Addendum #1 - Bid Package #6929-08

Project Name: Lincoln Public Schools District Office
5901 'O' Street
Lincoln, NE
Project No.: 11065
Issued: September 18, 2012

Sketch A8
 Bid Package 6929-08
 Addendum 01
 Modification to A1/A803

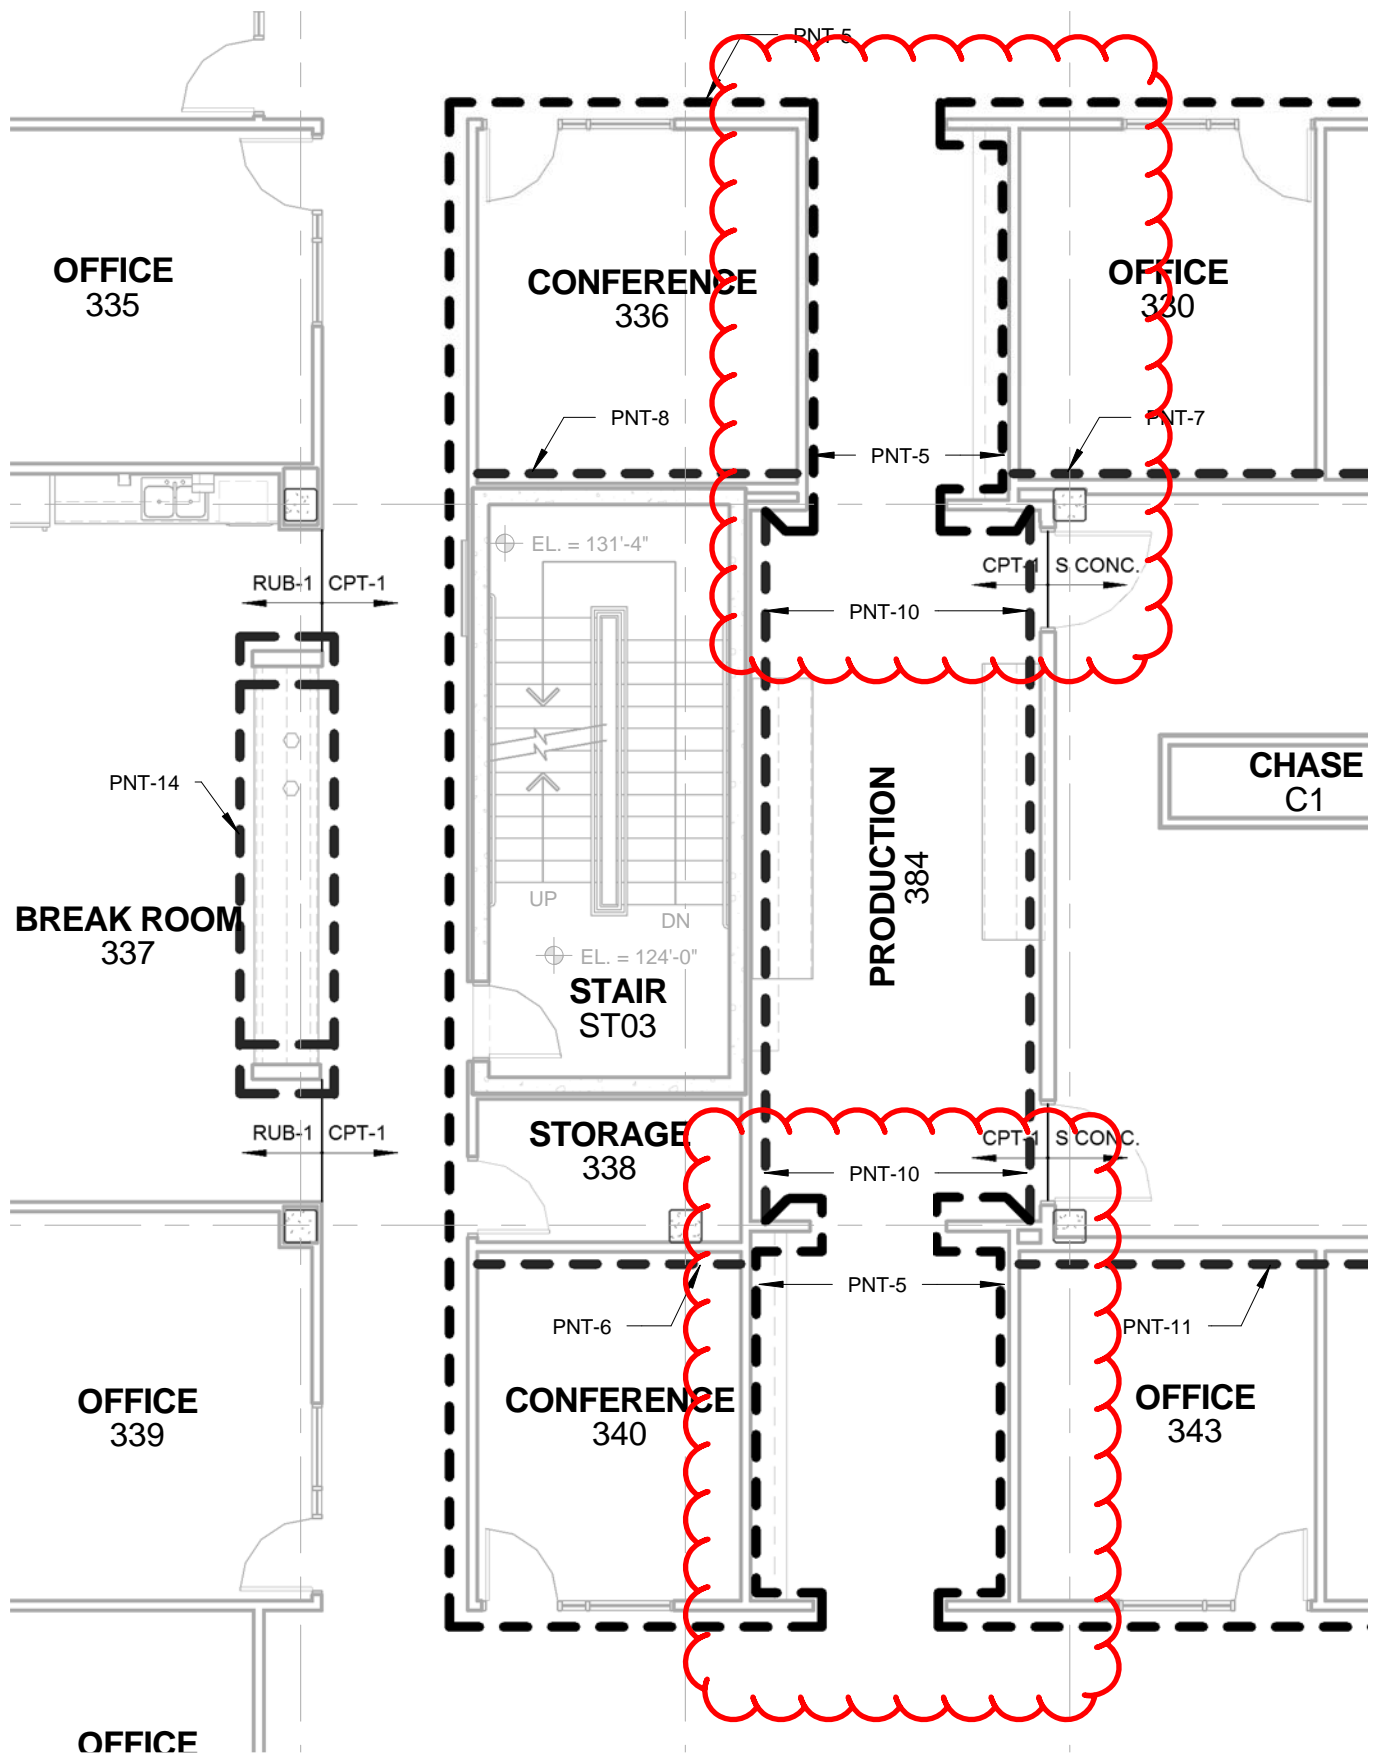
- ADD 1-62.** Refer to Sheet A803, Floor Transition Annotations at entry to Men 381B and Women 381G; The CT-1 should be changed to CT-4.
- ADD 1-63.** Refer to Sheet A803, Production 382; The paint color transition lines have been modified at the east and west ends to reflect what has been indicated in the Room Finish Schedules. Refer to attached **Sketch A8**.
